## Track and Hut Engagement Session 2 March 2023

### Milford Opportunities Hub – Te Anau

Figure 18: Node 2 - Eglinton reveal conceptual diagram (not to scale)

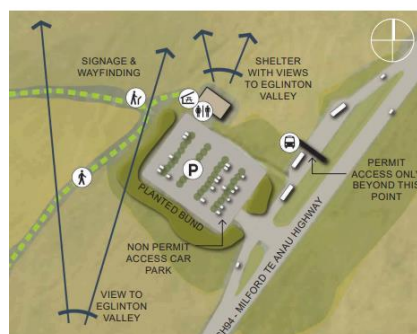
<b>Feedback</b>
Objective is to link to FTT.
There are over 40,000 passes per year on Lake2Lake already, track not finished. No question that there is demand for bike track.
What is planned service level for FTT section? Wilderness Trail, Grade 2 appears to be the sweet spot - very popular for older riders, locals, kids.
Accessibility, explicit about full access, wheelchairs etc. for bike track. Consideration for disability access within Master Plan? Needs to include access for younger age group, families with prams, trikes etc.
Grade 2 cycle trail would be used more (even with a few tricky bits), long sections 60 grade or less. Would be good for foot and bike traffic. Lots of people travelling around. Agree that Grade 2 with a few challenges would be the sweet spot. Would get used the most as a multiuse track. Great area to explore. Tracks like Wilderness Trail and Lake2Lake are good examples of tracks that cater for most.

Consideration on the impact track would have on camping.
Is there further capacity at Cascade Creek.
General support for track going through the valley, road is already there.
Provided an external reference about the benefits of a multiuse trail (MBIE report): <a href="https://www.mbie.govt.nz/dmsdocument/19854-2021-evaluation-of-nga-haerenga-great-rides-of-new-zealand-pdf">https://www.mbie.govt.nz/dmsdocument/19854-2021-evaluation-of-nga-haerenga-great-rides-of-new-zealand-pdf</a>
According to the 2013/14 Active NZ survey "Almost all participants took part in sport and recreation at one or more man-made facilities. The most popular being a path, cycleway or walkway in a town or city (53.1%)." Active NZ surveys: <a href="https://sportnz.org.nz/research-and-insights/surveys-and-data/active-nz/">https://sportnz.org.nz/research-and-insights/surveys-and-data/active-nz/</a>

The plan / notes could be explicit about the Reveal trail linking to the planned FTT trail at Te Anau Downs (jetty: some maps show 'Te Anau downs' as north of Retford hill). Initial plans only showed reveal to park boundary.

Short Walks at Te Huakaue Knobs Flat/ Kiosk Creek

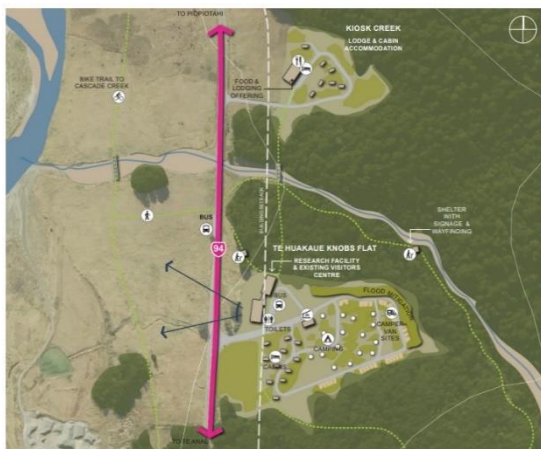
There are existing similar options e.g., Lake Gunn.

Enjoyed by people who require wheelchair and pushchair access.

Need to consider corridor / FNP, is that experience available elsewhere, and is it what people are wanting to do there?

Holistically, how much value would it add?

Cascade Creek is often full as accommodation is good.

Kiosk Creek's west-facing grassy terrace keeps the sun & are well suited to camping. Cascade has more developed flat pads suitable for vehicles.

Not that appealing to specifically go there for a day walk, but if you were staying there, the availability of a short walk(s) would be of value.

Short waterfall track already there - 25min return.

General support for short works. Potential for multiple short walks and potential to add some value for overnight option at Knobs Flat.

Figure 26: Mistake Creek Overnight Walking Track Experience conceptual location diagram (not to scale).

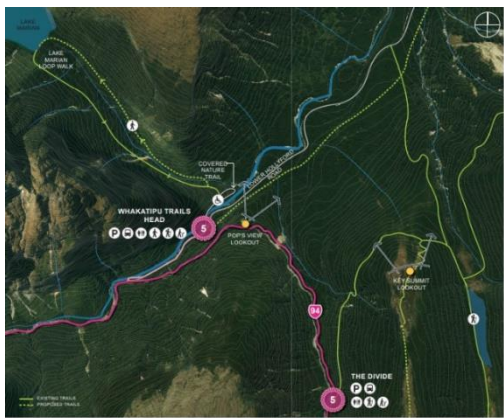
Concerned about the environment at the head of valley, avalanche hazard, pushing people up over U Pass, overhead hazards.

People have encountered grief in similar environments; therefore, we can expect similar issues. This could be exacerbated if promoted and opened up. Members concerned about the risk of the avalanche and hazard, promoting more people going into the area could push people into the pass itself into hazardous areas including avalanche risk. KC uses the example of Gertrude Saddle - people getting into grief. NZAC - open to having a new hut. It is an access point to a number of technical mountain climbs.

Mistake Creek – in the summer months it only has valley views, in the winter shade issue.

Maybe a smaller hut (and/or huts) rather the proposed 80 bunk. Proposes location like Countess Range. North of Boyd Ck. Close to Te Anau for access, ease of response with helicopter. Also, outside Fiordland National Park. Great views up Eglinton Valley, Te Anau basin - could loop track or destination in its. SBHS & Boyd Creek nearby, but we are proposing slightly further north up the Eglinton. Groups shown images from the location. Open to having new hut, but what and where.

Some confusion in the masterplan re U Pass.

Agree safety concerns, hazards - Mistake Creek.

Two bridges would reduce resilience.

Concerns re 80 bunks, congestion, diminish experience, alpine water supply, waste.

Potential to split the 80-bunk hut, 2 x smaller 40 bunk, but remains a significant impact on sewerage, water, footprint quite damaging and diminish the experience.

Figure 36: Node 6 - Gertrude Valley conceptual context diagram showing walking route to Gertrude Saddle (not to scale).

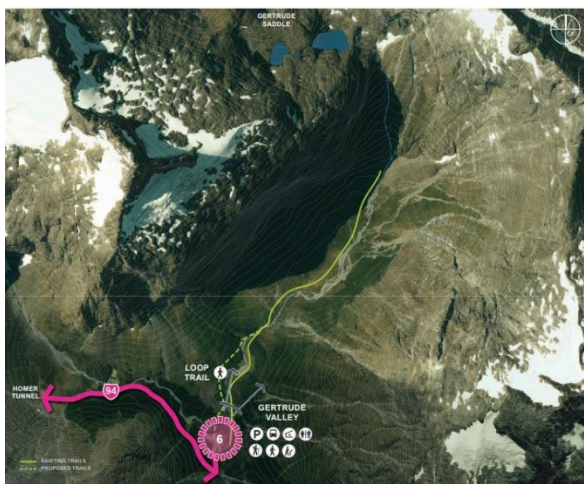
Feedback
Gertrude Valley walk - great scope for short walk loop. Track about the valley not the saddle.
Gertrude Saddle is already known, not creating a new hazard.
Great short stop, alpine flowers. Do not need to go up the saddle to get the experience. What is missing is the ability to stop in the alpine area and space and experience the Alpine flowers in the vista. It is a quintessential Fiordland experience.
Great majestic sense of place walking up the valley. Hazard mitigation, bunds etc - does not support - going into hazard then engineering out of it. The structures conflict with the objective of "Piopiotahi as it was forever". Hazard mitigation and infrastructure. Needs engineering and as soon as you build a structure then you are adding to some sort of environmental impact, and it is not part of the MOP vision.
Day visitors putting pressure on Alpine Club toilet and drinking water. New facilities would need to resolve this conflict and / or physical separation. Access for members to drive in but not for general use. The gravel in the creek keeps aggrading, needs maintenance to avoid flooding. Gertrude Saddle - lots of people come to strife irrespective of the signs. Is there potential to move the carpark to get people away from Gertrude Saddle?

General support for Gertrude but would require separation and engineering to avoid the conflicts.
Quiet enjoyment of the facility and risk to inexperienced visitors.

## Barren Pk Spur Walkway and Treetop Viewing Structures

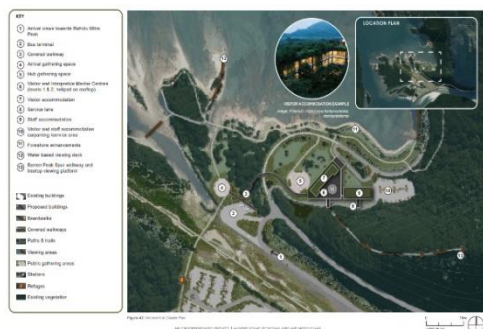
Feedback
Proposal to take track higher than present.
Concerned about the visual impact of any lookout structure plus people on structure – will draw attention of people on water (which is main Milford experience). Is in favour of the trail development ideas for Milford, both for locals (safe recreation) and for visitors. As with Knobs flat comments (which I related to staying at Makarora), it enhances your visit if you can be up early or in the evening for a walk. What the Milford Infrastructure can cope with in terms of numbers
Realistically speaking how long do people stay in Milford Sounds. Generally, it is around 3 hours. Is it necessary to have lots of option?
Fiordland - every time you add something it creates pressure - creates an impact. What does it look like to the wider network not just a point-to-point issue but look at the whole scope in totality?
Price point may be an additional challenge - how much will people pay. Would you have to pay for tree top walk?

Less value in the Bowen Valley walk.
Visual impact concerns.
Visitor safety with natural hazards on Barren Pk face.
Starting to offer too many options at Piopiotahi. Keeping people there for longer will impact on infrastructure required, energy, water, sewage.

## Hine-Te-Awa Bowen Falls Experiences:

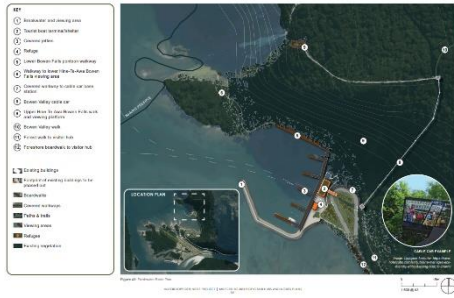
Feedback
Some method of getting up the Bowen for a walkway and look out over Bowen Falls.
Filled with dread the thought of a cable car, the visual impact of something moving. Less valley up Bowen Valley than Gertrude. These new structures can adversely impact other people's views.
Hydro pipeline needs replacing at some time, potential for a walkway up it. Existing infrastructure up to the penstock. The masterplan proposes some travelator walkway to Bowen falls.
Need to consider why people visiting the area, what is their expectation? Thinks it is about natural beauty not necessarily a structure etc. Is this about a colonised landscape, again inconsistent with the vision. Foreshore walk - gives vistas already. Put people at the top of views, they have an impact on other's observation. Cruise boats are a visual impact but a temporal one. If you can see the fiord from the structure, then you can see the structure / people from the fiord.

The longer people stay the more impact they have on power, water, waste, and hazard exposure. Instead of adding to Milford, you could subtract - move some things out of Milford?
Does not fit with the vision of the plan, 'NZ as it was forever'
Duplication with Barren Peak.
Any commercial feasibility in this?
Concerned about the visual impact

Impacts on visual amenity natural beauty could be diminished the natural features of the landscape and visitor experience the stated purpose the landscaping visit experience in the stated purpose on the MOP plan talks about *New Zealand as it was for the future*. This infrastructure did not seem to fit the plan.

If there was infrastructure, would need to be concealed.

Questions as to who would use it.

## Lower Pontoon Walkway:

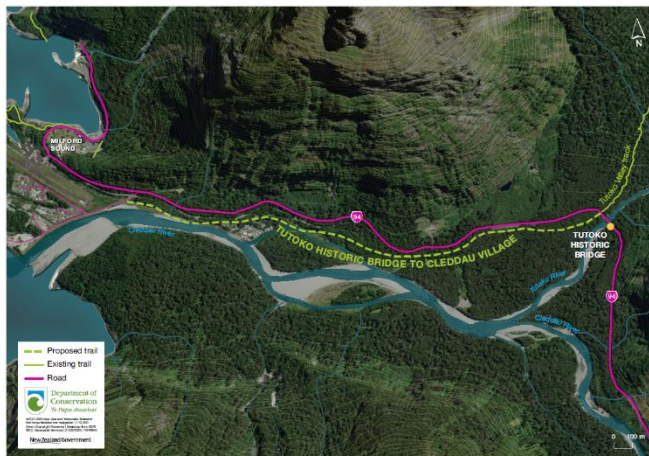
Bowen lower pontoon - hazard assessment? Known rockfall, tree slide hazard. Sceptical re the hazards.

**TUTOKO HISTORIC BRIDGE TO CLEDDAU VILLAGE WALKWAY:** A further opportunity exists to link Milford Sound Piopiotahi to the historic Tutoko River Bridge via a walkway, initially following the route of an existing informal walkway along the Cleddau Flood Protection Scheme to Milford Sound Lodge.

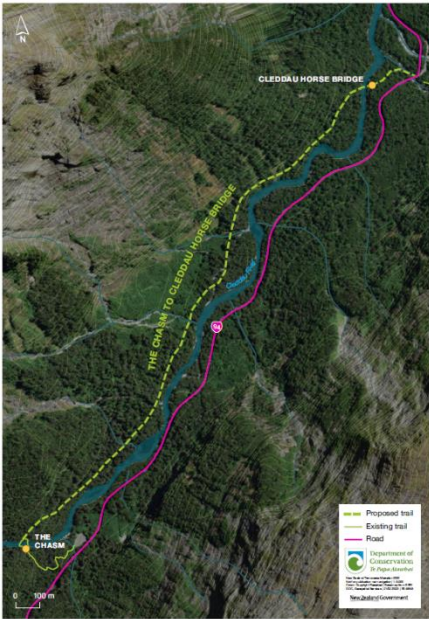
Have been canvassing DOC & NZTA for walking track to get people off the road.

Safety, speed. Helpful but still an issue. Have an informal track to a reasonable standard but needs a foot access culvert. Strong advocate for free options for people who go to. Declares a conflict of interest as any track would benefit Milford Lodge guests.

Currently guests walk down the road. There is already a formed track, but not good enough for some guests. Missing a culvert pipe

Milford Sound residents do not have access to exercise tracks to recreate in. Residents exercise on the road, they wait for the traffic to die away.
